# MEMO

Date: November 11, 2019

Re: Review for COHATCH new construction at 25 North Street

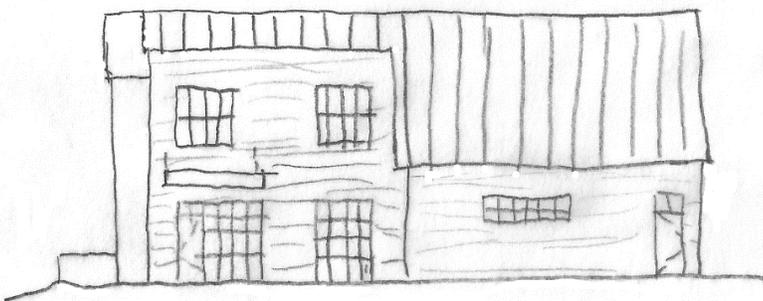
- The elevation is disjointed and does not read as a cohesive whole.
- The overall height and mass of the building is too large for the neighboring structures of the historic district and overpowers them. Consider lowering the roofline so that it matches or is below that of the neighboring structure on N. High Street. In addition, consider reducing the overall size of the building so that it does not overpower the smaller residences in the area.

- The front-gable roofs have different slopes and are not centered on the mass of the building below. They appeared disjointed and do not read as a cohesive whole. They should match or mimic the gable of the neighboring historic building and be centered. Or at least the gables should match like the sawtooth roofs of early factory buildings.

- Overall, the windows are too large with no divisions. Consider dividing the storefront windows into small sections of three and providing additional mullions or using divided lights. Color and material are appropriate for a modern storefront window in a commercial building.

- The windows on the upper floors also need to be articulated and placed in a pattern—they are disjointed in the current rendering. I would suggest dividing them into double or triple sash or casement or fixed windows with mullions and/or divided lights so they blend better with those in the surrounding historic district. Color is appropriate for a modern commercial building.

- Remove the rear overhang along Blacksmith Lane. It does not read structurally—the thin columns do not appear like they can support the massive two-story structure above. Overhangs may have appeared in historic buildings, but not to this extent.

8. Sketch of the front (north) elevation on North Street. The overhang and thin metal columns have been removed and replaced with a canopy covering the entry doors. The windows now relate to one another and have divided lights and mullions to reflect neighboring residential structures. The gables roofs now have the same slope and are centered over the mass of that portion of the building.
